## Department of Transportation

Subject: WisDOT Interstate Study Staff Review

Date: July 5, 2023

### Alternative 1 Summary of Impacts

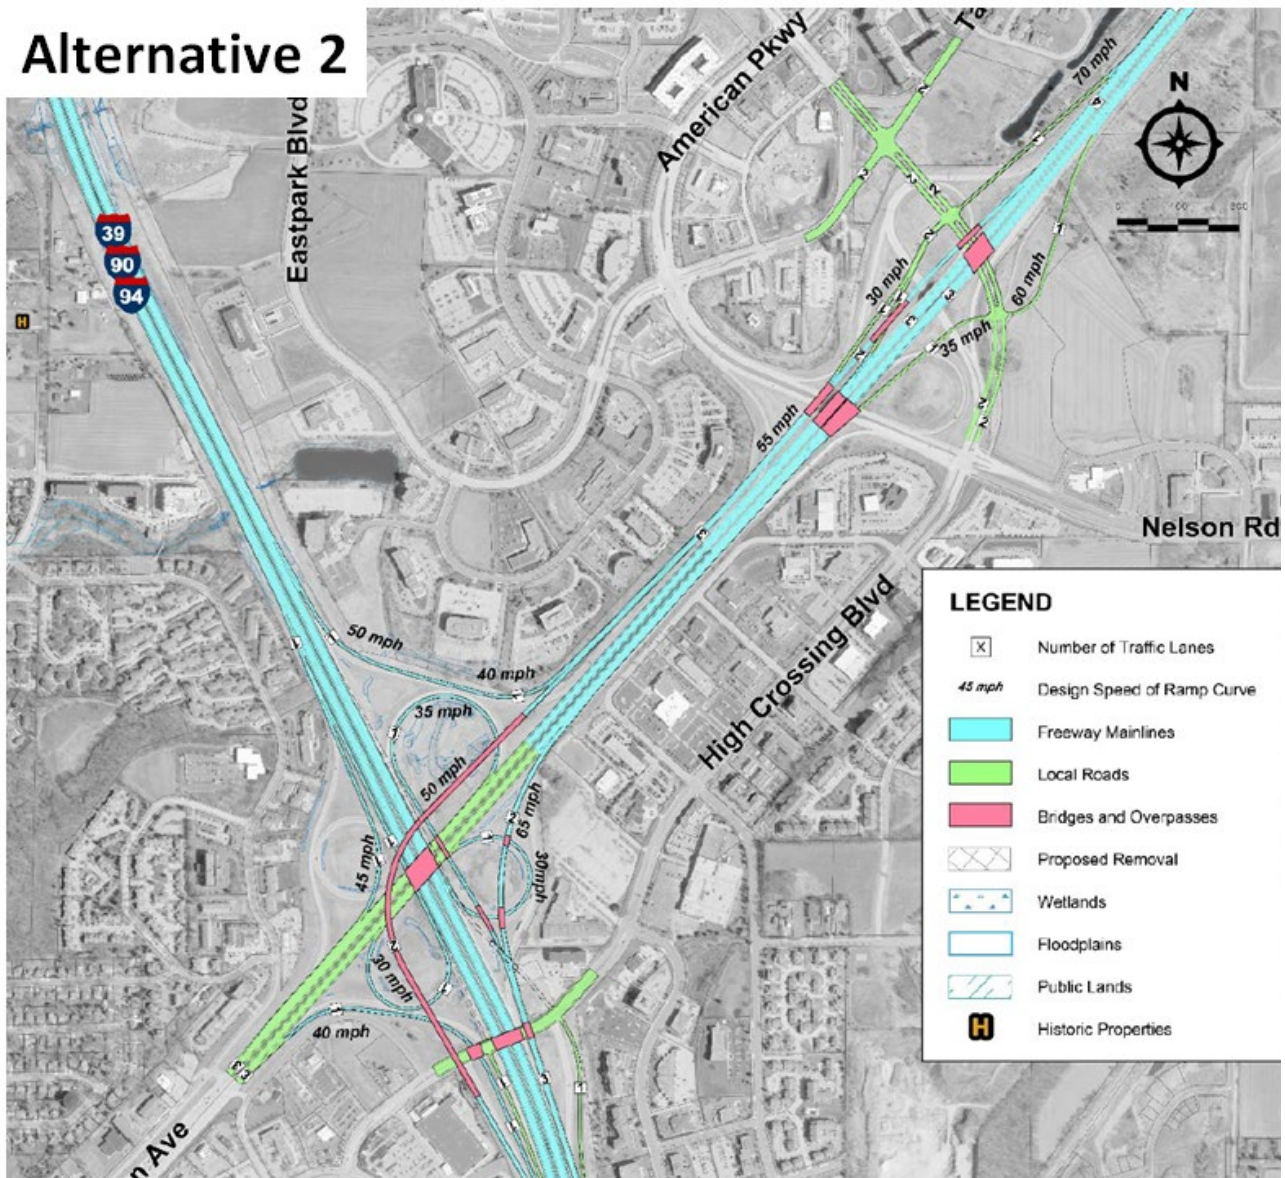
1. The signals on the East Washington Ramp terminals would help introduce an urban roadway with slower speeds.
2. There is no urban street connection to the American center with this alternative. Access without a motor vehicle remains difficult.
3. There is one elevated freeflow ramp, which could increase noise impacts.
4. This alternative would not influence density or development opportunities.
5. This alternative would not enhance BRT routing to the American Center.
6. This alternative relocates the US 151 entrance of the American Center from American Parkway to American Family Drive, yet maintains the Nelson Road/American Pkwy entrance from High Crossing Blvd.

### Alternative 2 Summary of Impacts

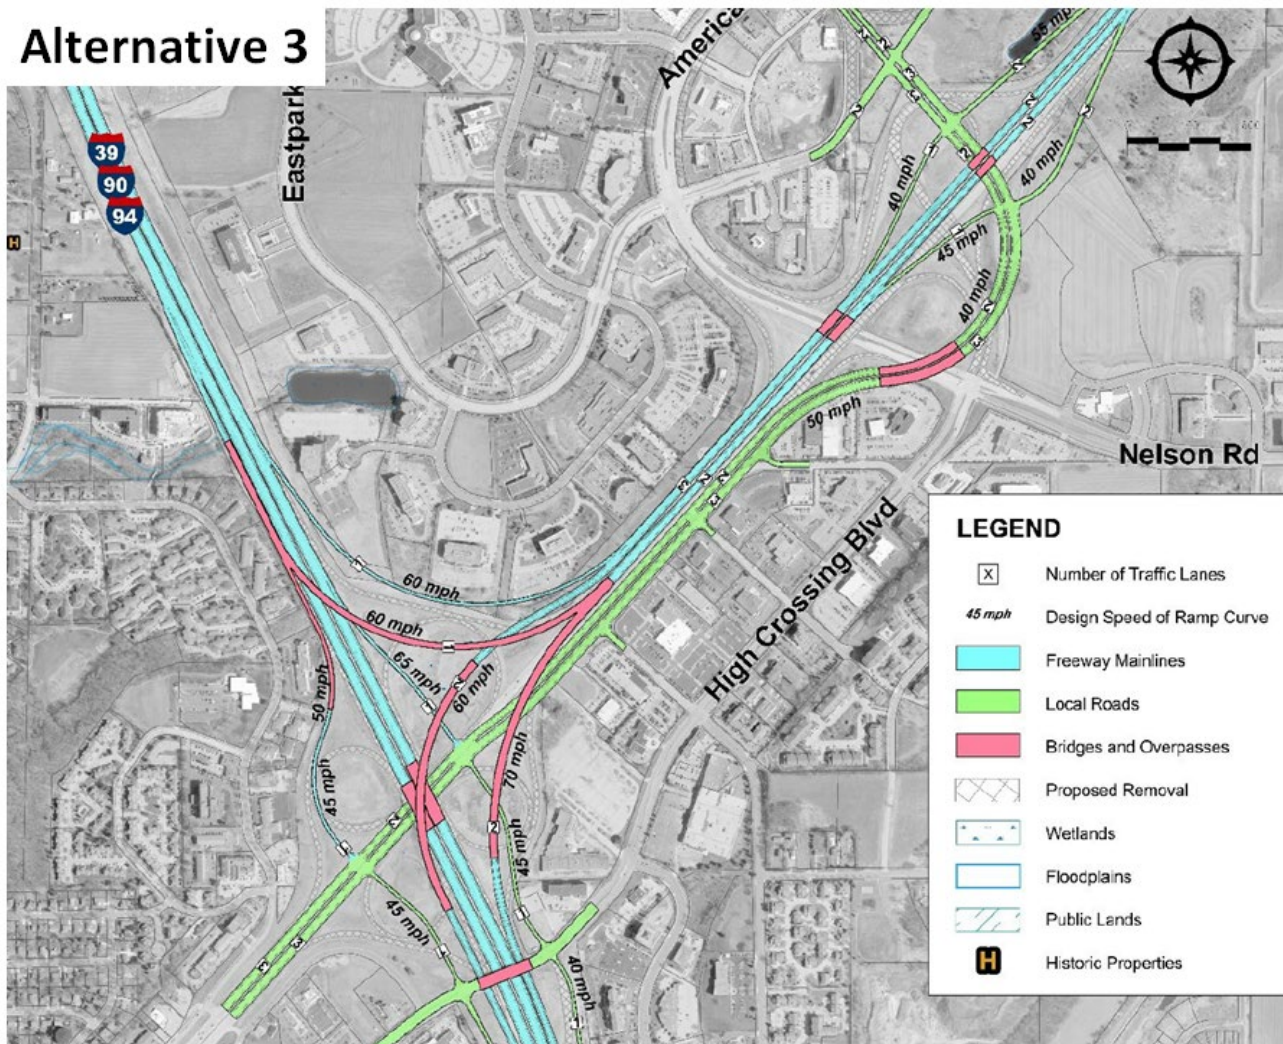
1. The cloverleaf ramps remain, and East Washington speeds would remain high.
2. There is no urban street connection to the American Center with this alternative. Access without a motor vehicle remains difficult.
3. There is one elevated freeflow ramp, which could increase noise impacts.
4. This alternative would not influence density or development opportunities.
5. This alternative would not enhance BRT routing to the American Center.
6. This alternative relocates the US 151 entrance of the American Center from American Parkway to American Family Drive, yet maintains the Nelson Road/American Pkwy entrance from High Crossing Blvd.

### Alternative 3 Summary of Impacts

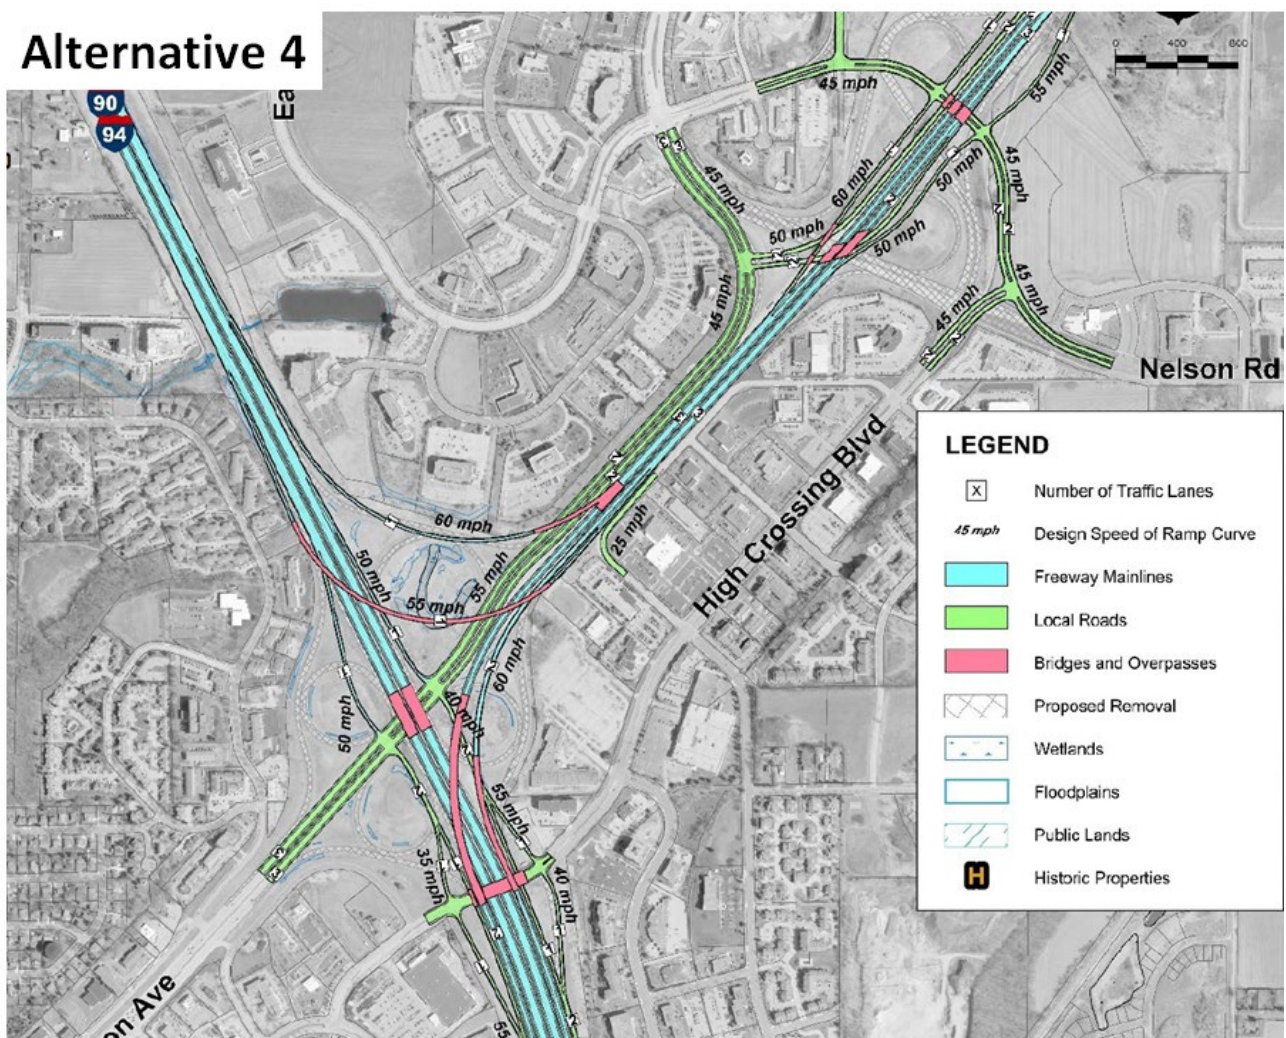
1. The signals on the East Washington Ramp terminals would help introduce an urban roadway with slower speeds. Additionally, the extension of East Washington Ave as an urban street with intersections would help to slow travel speeds east of the Interstate.

2. There is an urban street connection to the American Center with this alternative, which provides direct access for cyclists, pedestrians, and auto users who do not want use the freeway. This helps connect the American Center with the rest of the city. The urban street runs adjacent to the freeway, which could be less comfortable for some users.

3. There are three elevated freeflow ramps, which would increase noise impacts.
4. This alternative could enhance density or development opportunities. The extension of East Washington Ave along Wayne Terrace provides better access and visibility to the High Crossing area. This could create higher and better (denser) uses for the properties between Wayne Terrace and High Crossing.

5. This alternative probably would not affect BRT routing to the American Center. BRT probably would continue on High Crossing to serve the residential areas south.

6. This alternative relocates the US 151 main entrance of the American Center from American Parkway to American Family Drive through a diamond interchange. Access to American Parkway is maintained through High Crossing Blvd.

### Alternative 4 Summary of Impacts

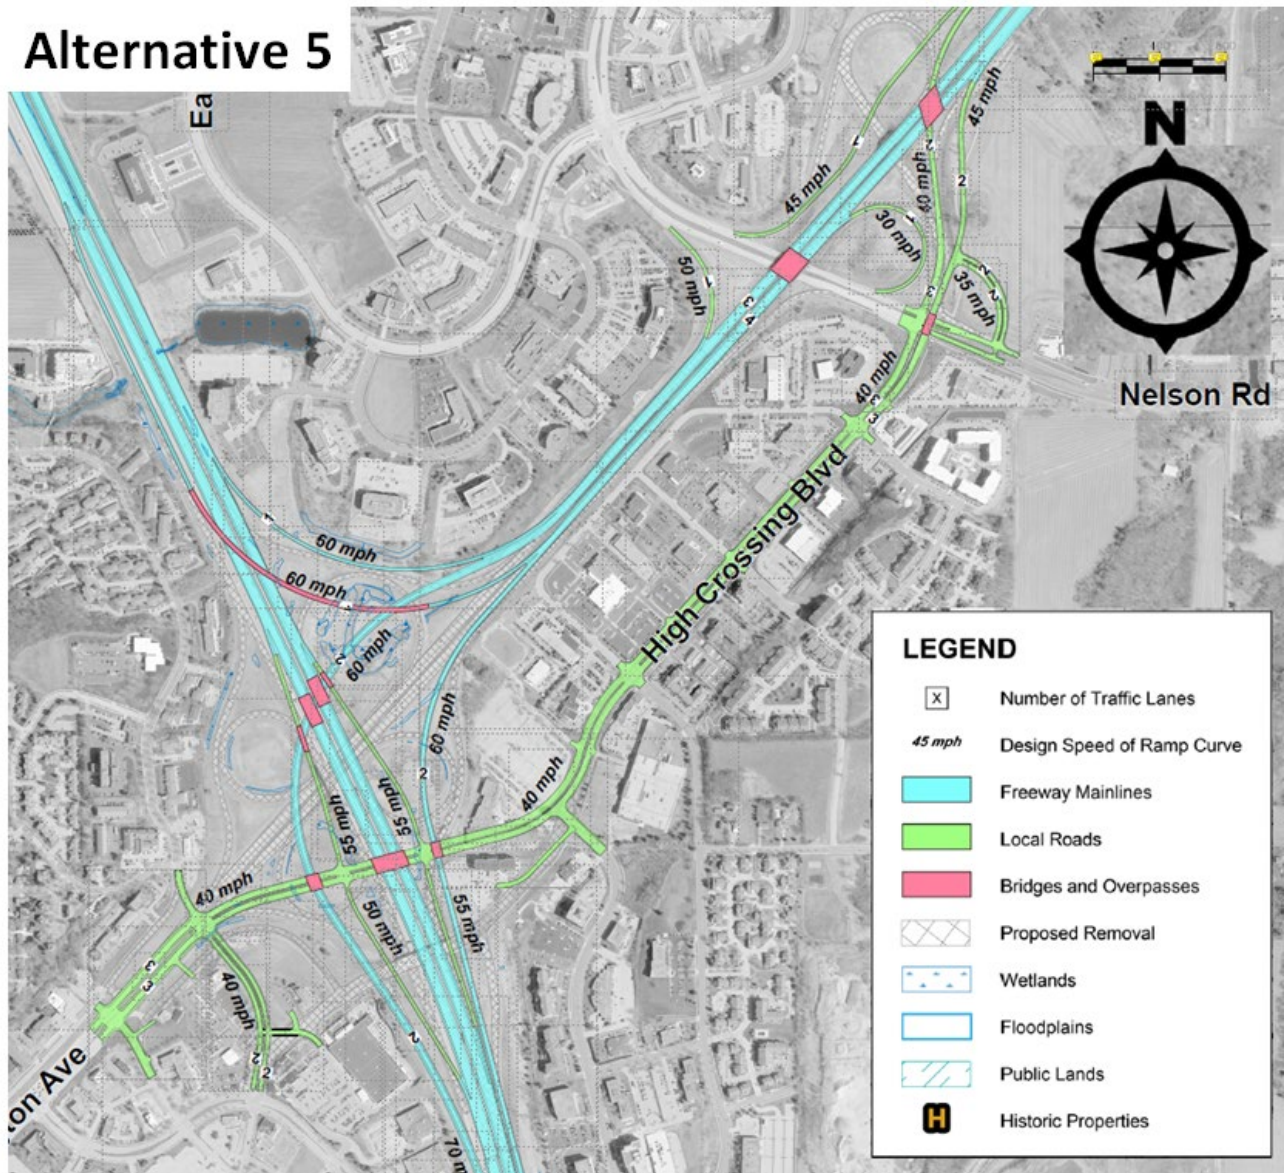
1. The signals on the East Washington Ramp terminals would help introduce an urban roadway with slower speeds. However, the East Washington Ave extension would not provide as much speed moderation because there are no intersections or property accesses. This section of roadway would encourage higher than normal travel speeds.

2. The urban street connection to the American Center provides direct access for cyclists, pedestrians, and drivers who do not want use the freeway. Speeds on the East Washington Ave extension are a concern.

3. There are three elevated freeflow ramps, which would increase noise impacts.
4. This alternative would not enhance density or development opportunities. There is no property access or street intersections off of the extension, therefore the street would serve mainly as a local connection.

7. This alternative probably would have no effect on BRT routing to the American Center. BRT probably would continue on High Crossing to serve the residential areas south.

8. This alternative creates an addition US 151 entrance to the American Center through a modified diamond interchange connection of Nelson Road with Eastpark Blvd. It also provides an option for US 151 travelers to connect directly with the American Parkway/East Washington Ave extension.

#### **Alternative 5 Summary of Impacts**

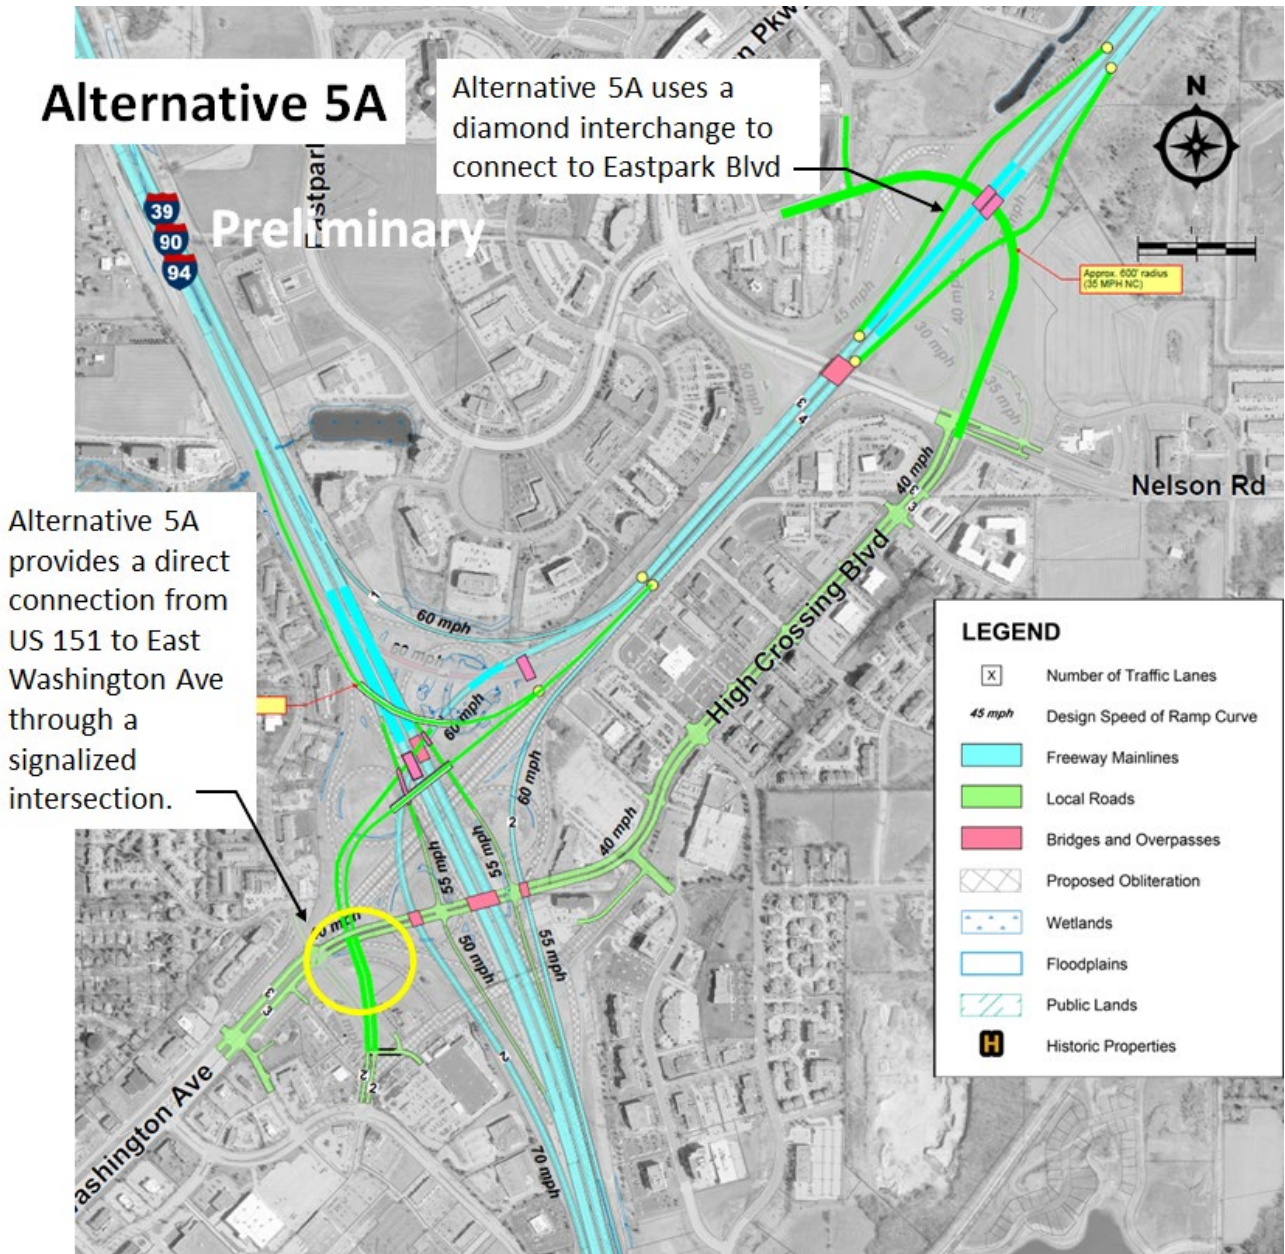
1. The signals on the East Washington Ramp terminals would help introduce an urban roadway with slower speeds. Additionally, East Washington Ave as an urban street with intersections is extended northeast to Nelson Road/American Family Drive. The use of High Crossing Blvd as an urban street would also help to slow travel speeds, introducing city speeds a full mile east of the Interstate.

2. The urban street connection to the American Center provides direct access for cyclists, pedestrians, and drivers who do not want use the freeway, better connecting the American Center with the rest of the city.

3. There is only one elevated freeflow ramp, and two depressed freeflow ramps. The elevated ramp would increase noise levels, however the two depressed ramps would have lower noise impacts than Alternatives 3 and 4.

4. This alternative would enhance density or development opportunities. High Crossing Blvd is underutilized and has high redevelopment potential. The extension of East Washington Ave onto High Crossing Blvd would provide better access and visibility.

5. This alternative would enhance BRT routing to the American Center. Combining East Washington with High Crossing Blvd eliminates turns and provide a more direct connection to both the American Center and the Sun Prairie Park and Ride.

6. This alternative maintains the current main entrance of the American Center from American Parkway to American Family Drive through a jug handle similar to the current access. An additional access into the American Center is not provided.

Note: WisDOT is proposing expanding High Crossing Blvd. to three lanes in each direction with this alternative. With High Crossing Blvd. currently seeing approximately 15,000-18,000 average weekday traffic, which is low for a road of its size, Staff has encouraged WisDOT to examine traffic projections to see if this alternative requires an expansion of High Crossing Blvd. Similarly, staff has requested further information from WisDOT as to whether the jug handle shown at Nelson Road is needed.

## Hoepker Interchange

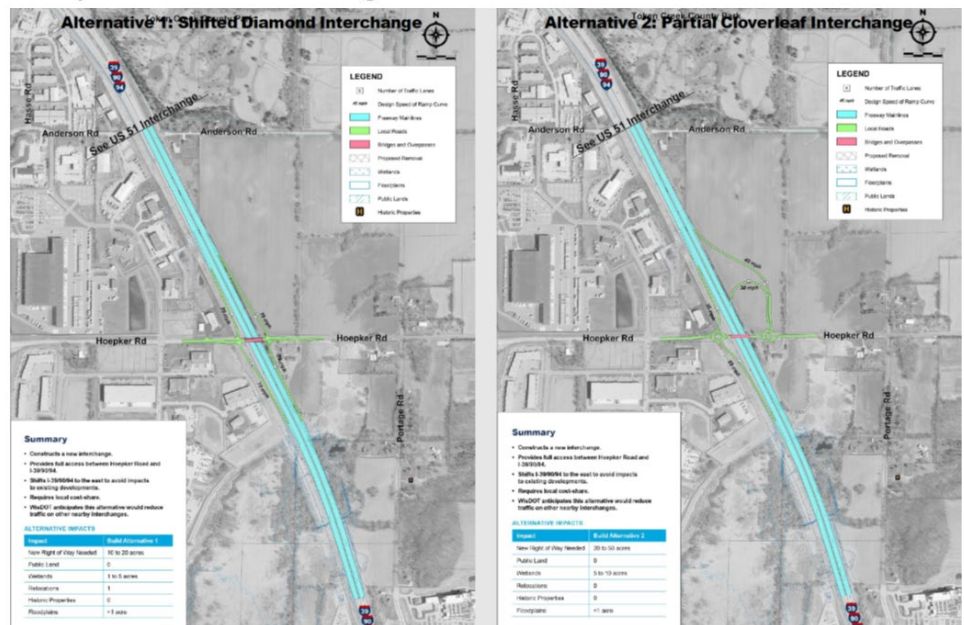
Reconstruction of the Interstate provides the opportunity to evaluate the installation of a new interchange at Hoepker Road. Stakeholders in the American Center have advocated for the installation of a new interchange at Hoepker Road. This interchange is not in the current Pumpkin Hollow Neighborhood Development Plan. It would provide more direct interstate access to employment and regional medical facilities in the American Center. It also would provide access to Sun Prairie's Prairie Lakes retail center via Hoepker Road.

The configuration of a potential interchange, either a standard diamond or partial cloverleaf, will largely be determined by WisDOT traffic modeling.

Preliminary Travel Demand Modeling was provided by WisDOT for the 2050 forecast year. If the US 151 Alternative 5 interchange is used as a base, the 2050 modeling indicates that Portage Road south of Hoepker Rd. would see roughly 2000 more vehicles per day (vpd), bringing the total to roughly 4000 vpd. The total daily volume is still well within the capacity of a typical two-lane roadway. Hoepker Road would see greater traffic volume increases, with up to 10,000 vpd being added to Hoepker Road east of the interstate. This would bring Hoepker Road traffic volumes to 20,000 vpd or above, perhaps affecting the capacity need on Hoepker Rd.

The City of Madison would be responsible for paying a local cost share associated with interchange construction. Madison has a policy that passes that cost onto benefiting properties through assessments/impact fees. This policy could be revised to include other funding sources. The Neighborhood Development Plan would also need to be modified to reflect land use changes that could occur with a new interchange.

## Milwaukee Street Interchange

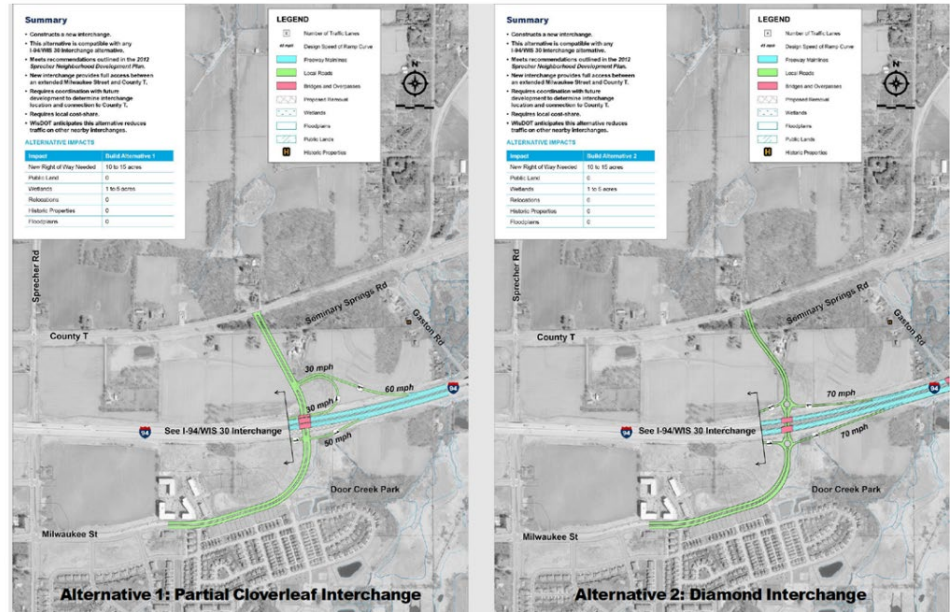
The I-94 reconstruction also provides an opportunity to construct an interchange off an extension of Milwaukee Street. This interchange has been part of the Sprecher Neighborhood Development Plan for two decades, and is necessary for the commercial/ employment uses in the Neighborhood Development Plan and Comprehensive Plan to be realized. The Milwaukee St interchange could enable a commercial/ employment/ mixed-use node similar to highway frontage projects like Arbor Gate (by Todd Drive) or the “City Center West” area southwest of the Beltline/Old Sauk Road interchange (TDS/Johnson Bank, Deco mixed-use building, etc).

WisDOT provided preliminary Travel Demand Modeling for the 2050 forecast year. If the US 151 Alternative 5 is used as a base, there would be very modest changes to traffic in the area. Milwaukee St west of Sprecher would see a 10 to 15 percent increase of daily traffic volume. Sprecher Rd south of Milwaukee St. would see less than a 5 percent increase in traffic volume.

An interchange at this location provides new access opportunities for residents in the Sprecher neighborhood, as well as enhancing emergency response times from nearby Fire Station No. 13. With an interchange planned in the Sprecher Neighborhood Development Plan, Milwaukee Street has generally been constructed to accommodate additional traffic in this area. The Common Council adopted a resolution supporting study of a Milwaukee Street interchange in 2017 (see [Legistar #48640](#)).

As with the Hoepker Road interchange, the City of Madison would be responsible for paying a local cost share associated with the interchange. Madison has a policy that passes that cost onto benefiting properties through assessments/impact fees. This policy could be revised to include other funding sources, which for this area could include Tax Increment Financing (TIF)<sup>1</sup>.

This is probably the only opportunity in the coming decades to install this interchange. If the city were to decide not to install it, the Neighborhood Development Plan and Comprehensive Plan should be modified to reflect no access to the Interstate system, which would likely mean multifamily residential replacing planned employment.
